Great River Hydro

**Re: Great River Hydro, LLC; FERC Project Nos. 1855-050, 1892-030 and 1904-078
Response to License Application Additional Information Requests**

Cost of Environmental Measures

AIR 4, Figure 1. Detection zone of monitoring station downstream of Vernon Dam. Receiver location designed for ILP Study 21 (American Shad Telemetry) in 2015.

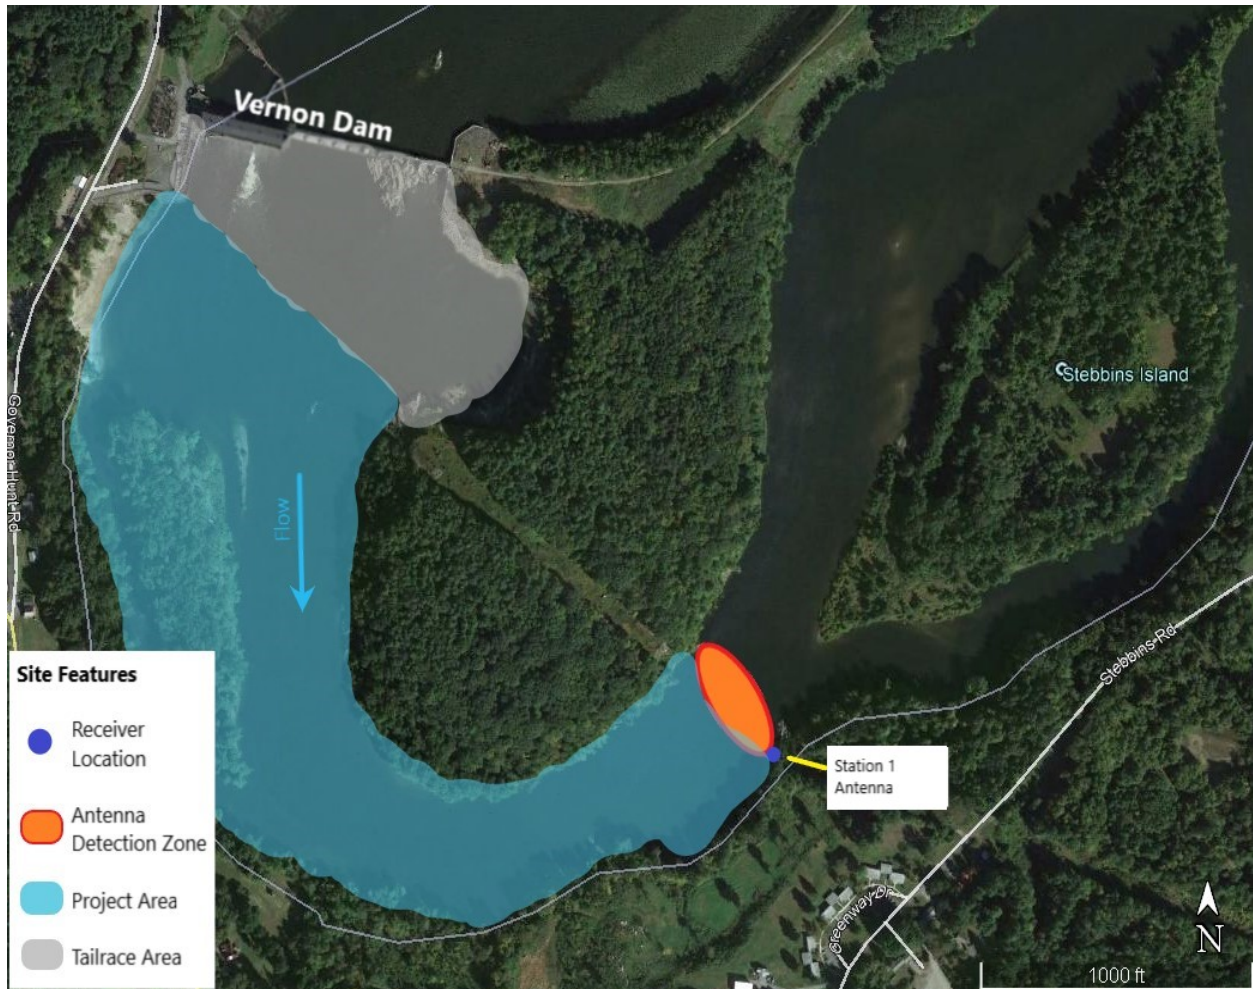
AIR 4. In section 3.6.2.7 of Exhibit E, Great River discusses observations of adult sea lamprey utilizing the upstream fish passage facility at the Vernon Project (n = 2,440) in 2015. In Study 16 (Sea Lamprey Spawning Assessment),¹ Great River states that 18 of the radio-tagged sea lamprey from FirstLight's Turners Falls Hydroelectric Project and Northfield Mountain Pumped Storage Project relicensing studies were subsequently detected at the Vernon Project. Please confirm the total number of radio-tagged sea lamprey that utilized the Vernon Project's fish ladder, the date/time they were first detected near the ladder entrance, the data and time they entered the ladder, and the date/time they exited the ladder.

Monitoring stations used during the American shad telemetry study at Vernon are presented in Figures 1 and 2. Descriptions and functionality for each of the monitoring stations during the fish passage study period are described within the ILP Study 21 report. The fishway monitoring stations in ILP Study 21 (Figure 2) were set up with both PIT and radio receivers to evaluate upstream passage efficiency for American shad. Unlike the dual-tagged American shad released as part of Study 21 (i.e., individuals

carrying both a PIT and radio transmitter), sea lamprey originally released by FirstLight did not carry a PIT transponder, limiting any fishway use and passage efficiency assessment to radio-telemetry data. Radio antennas were positioned to detect fish in the tailrace near the fishway entrance (i.e., the “fishway attraction flow” or “near field area”), the fishway entrance, the counting house window, and the fishway exit. The fishway attraction flow monitoring station was configured to detect fish in the vicinity of the fishway entrance, in the attraction water flow field. This receiver was coupled to a switchbox using an underwater dropper antenna at the fishway entrance and to a 4-element antenna with a detection area of approximately 30 feet paralleling the attraction flow to provide coverage within the immediate zone of attraction. Together these two antennas were able to identify the presence of radio-tagged sea lamprey within the vicinity of the fishway entrance and immediately inside. The date and time of the first detections on the dropper antenna were used as the initial entry into the fishway. In the case that there were no detections on the dropper antenna, duration and signal strength of detections on the aerial antenna covering the “fishway attraction flow” were used as the initial approach into the entrance. Date and time of the initial detections at the counting window and fishway exit receivers were also recorded.
